DOCKET NO. 40-9027
LICENSE NO. SMC-1562
LICENSEE: CABOT PERFORMANCE MATERIALS, REVERE, PA
SUBJECT: SAFETY EVALUATION REPORT, SITE
DECOMMISSIONING PLAN, AND RADIOLOGICAL
ASSESSMENT, DATED MAY 24, 2001

This safety evaluation report (SER) has been prepared in response to the latter DP, RA and informational letter. If the latest DP and supporting materials are approved, the Revere site will be removed from the license and released for unrestricted use.

Figure 1. Generalized conceptual model used in the Cabot-Revere assessment.

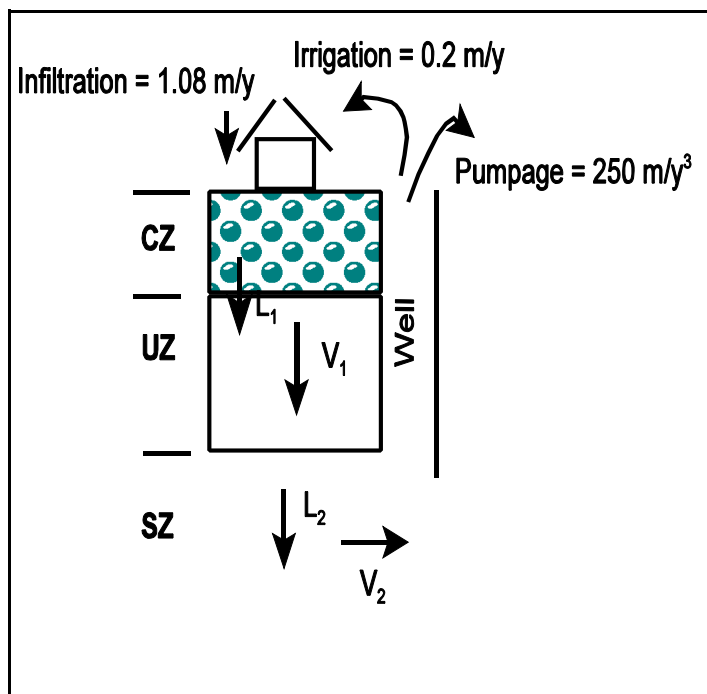
It should be noted that a default irrigation rate of 0.2 m/yr (0.7 ft/yr) was used in the analysis, although the licensee only assumed irrigation as part of its residential gardener scenario.

Based on regional information, the unsaturated zone is believed to be roughly 20 m (66 ft) thick; however, for the assessment, nominal credit is taken for the possible hold-up of contaminants migrating through the unsaturated zone. This is reflected by the small unsaturated zone thickness [0.01 m (0.03 ft)] assumed for the analysis. Staff believes that this adds conservatism to the calculated doses for the water-dependent pathways.
